SITE SURVEY DRAWING FOR SOIL ANALYSIS LOCATIONS

SITE ASSESSMENT REPORT

TOWNSHIP: Ohio SECTION: 25 DATE: 4-14-97
SUBDIVISION: Parcel 2400 Site One LOT NO.:
FRONTING ON: West SIDE OF: SR 58 APPROXIMATELY: 3/4
(FEET-MILES): North OF: 700 S. (NEAREST CROSS ROADS)
ACRES: 22 DIMENSIONS:
PROPOSED ACRES: AND DIMENSIONS:
OWNER: Louis Joyner ADDRESS: 2824 Riverside Drive
REQUESTED BY: Louis Joyner PHONE: 372-0332 Work
MAILING ADDRESS: 2824 Riverside Drive, Columbus, IN 47201
SOIL(S): Cincinnati STRUCTURE: mod. subangblky TEXTURE: silty clay loam
LIMITING LAYER: fragipan 38-60" SLOPE: 2-15% LOADING RATE: .3

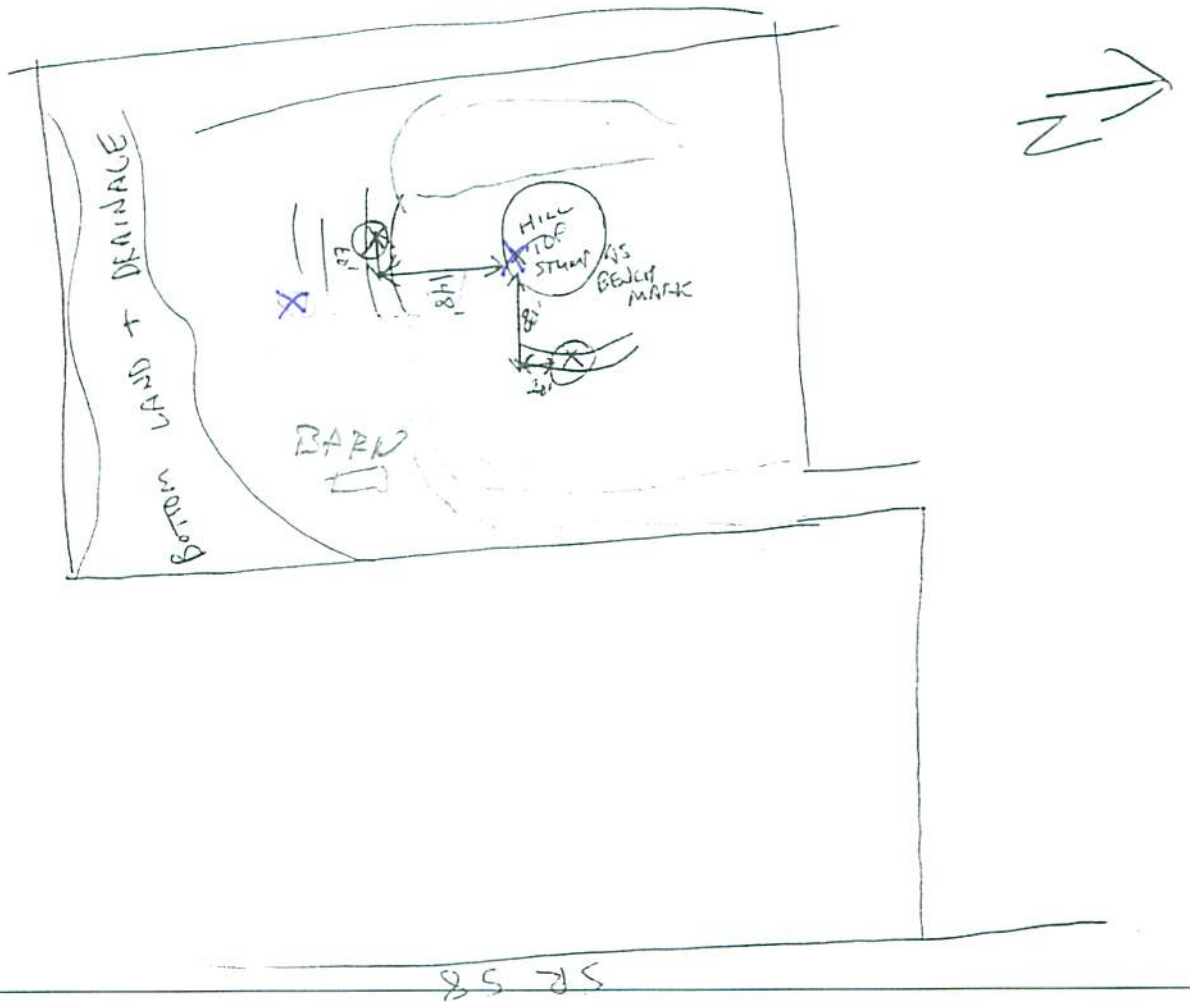
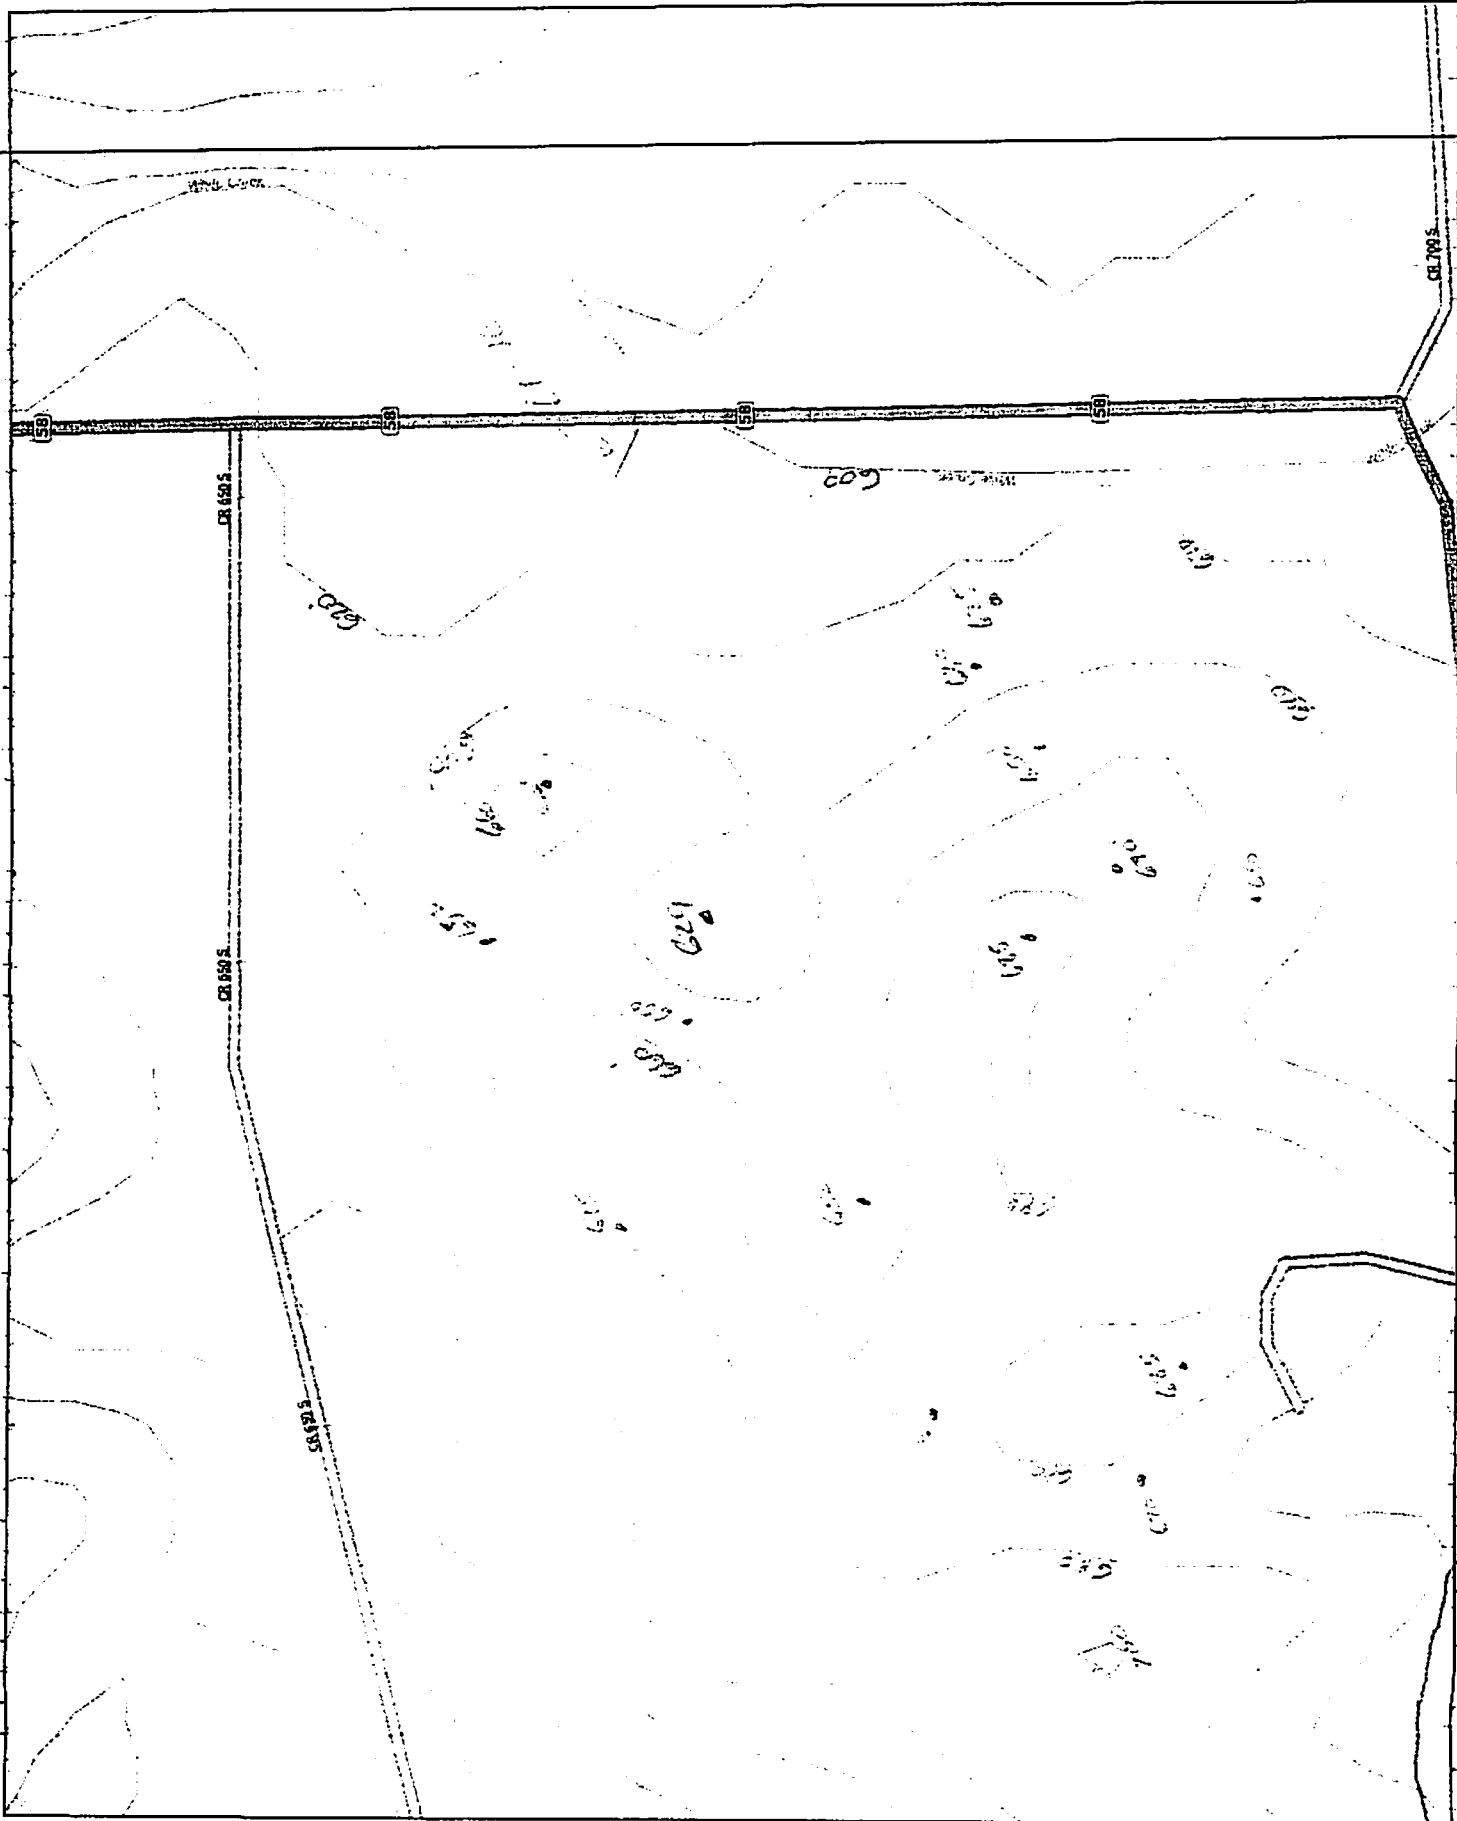
THIS PROPERTY IS: NOT ACCEPTABLE: ACCEPTABLE: X WITH THE
FOLLOWING REQUIREMENTS
REQUIREMENTS BASED ON SOIL ANALYSIS CONDUCTED BY AL DONALDSON MARCH 20, 1997

1. Install a septic tank with a gas tight riser sized according to the number of bedrooms in the home.
2. Install an appropriately sized pumping chamber for three or more bedrooms. Install pump sized to deliver daily design load at 30-60 gpm. Install an audible and visible alarm for the pump.

3. Install 500 square feet of subsurface absorption field per bedroom in trenches not to exceed 14 inches in depth. Addition fill to be applied to cover aggregate with 12 inches of soil. Maximum square footage possible must be verified on-site prior to issuance of construction permit.

4. Install a perimeter drain up slope and along side slope at a minimum depth of 40 inches located no closer than 10 feet from septic absorption field.

5. A diversion ditch is to be installed up slope with sufficient depth and fall to move surface water to the side and away from the septic field.
6. The septic field is to be located directly East of the home site at soil boring one. Any alteration of this area may render the site unsuitable.

SITE SURVEY DRAWING FOR SOIL ANALYSIS LOCATIONS

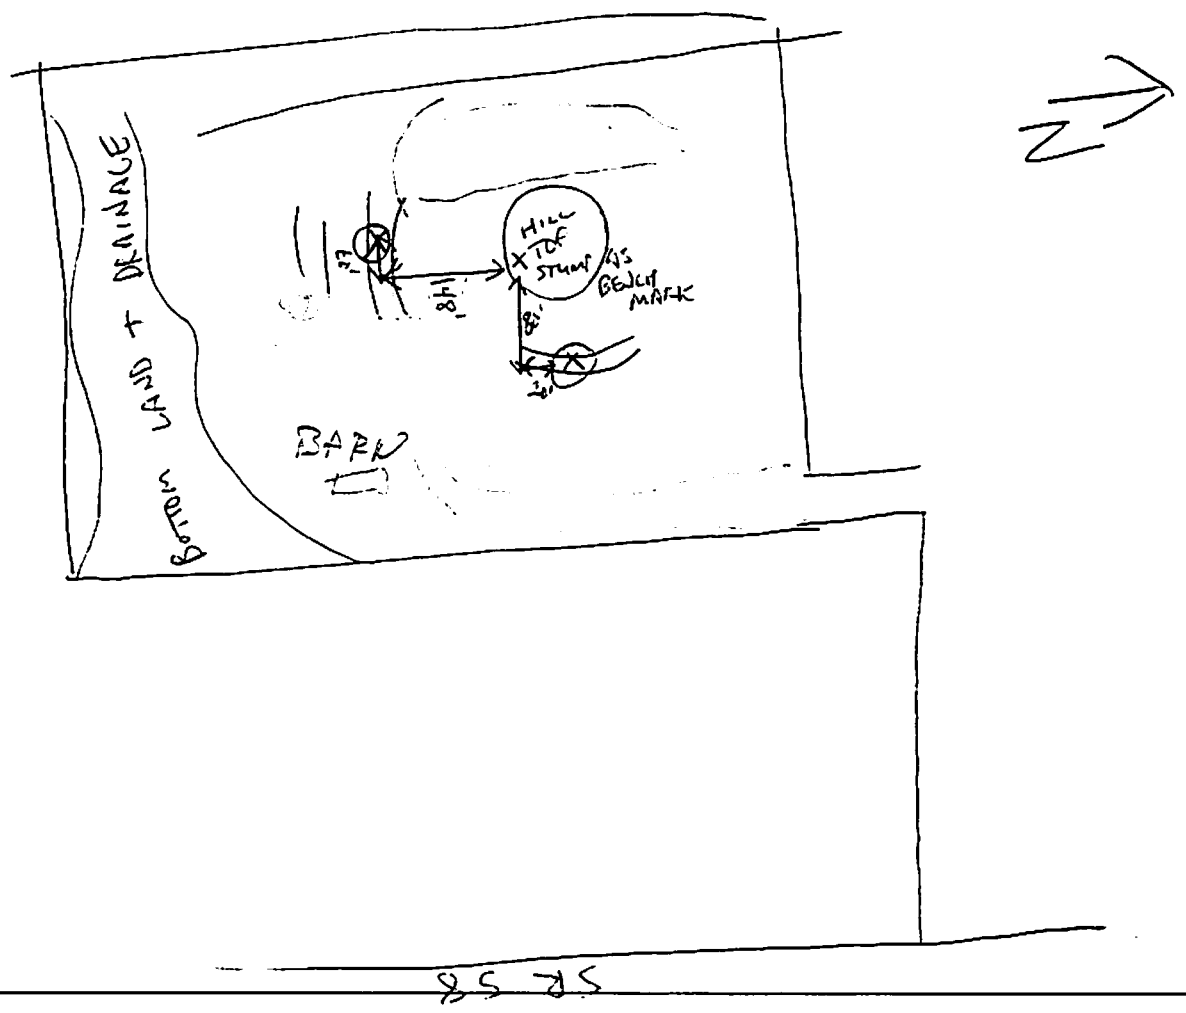
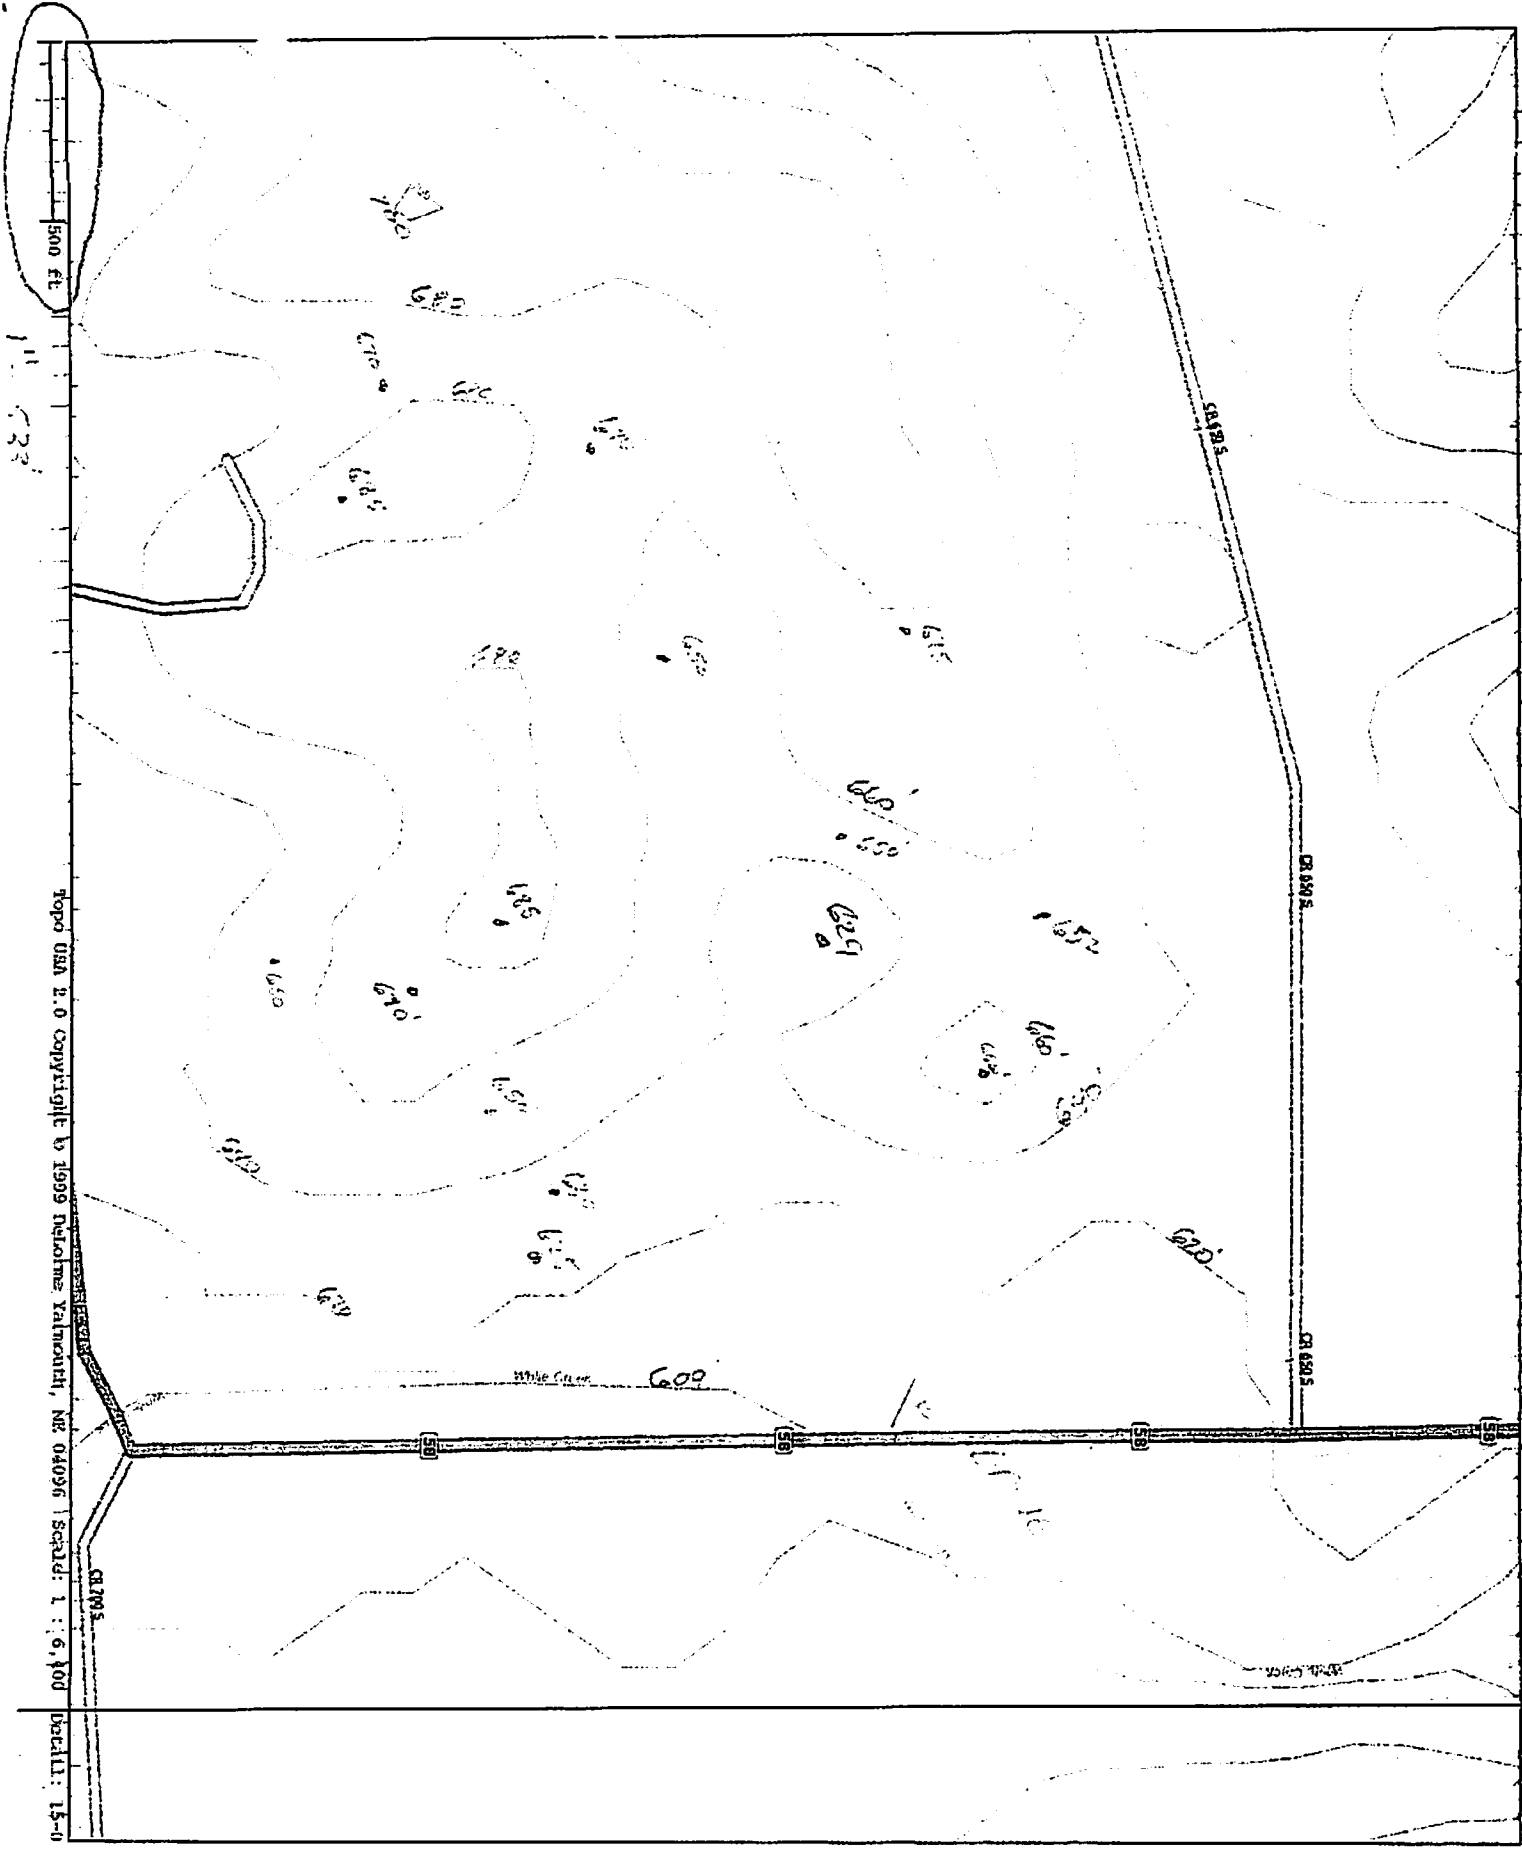
THIS PROPERTY IS: NOT ACCEPTABLE: ACCEPTABLE: X WITH THE
FOLLOWING REQUIREMENTS
REQUIREMENTS BASED ON SOIL ANALYSIS CONDUCTED BY AL DONALDSON MARCH 20, 1997

1. Install a septic tank with a gas tight riser sized according to the number of bedrooms in the home.
2. Install an appropriately sized pumping chamber for three or more bedrooms. Install pump sized to deliver daily design load at 30-60 gpm. Install an audible and visible alarm for the pump.

3. Install 500 square feet of subsurface absorption field per bedroom in trenches not to exceed 14 inches in depth. Addition fill to be applied to cover aggregate with 12 inches of soil. Maximum square footage possible must be verified on-site prior to issuance of construction permit.

4. Install a perimeter drain up slope and along side slope at a minimum depth of 40 inches located no closer than 10 feet from septic absorption field.

5. A diversion ditch is to be installed up slope with sufficient depth and fall to move surface water to the side and away from the septic field.
6. The septic field is to be located directly East of the home site at soil boring one. Any alteration of this area may render the site unsuitable.
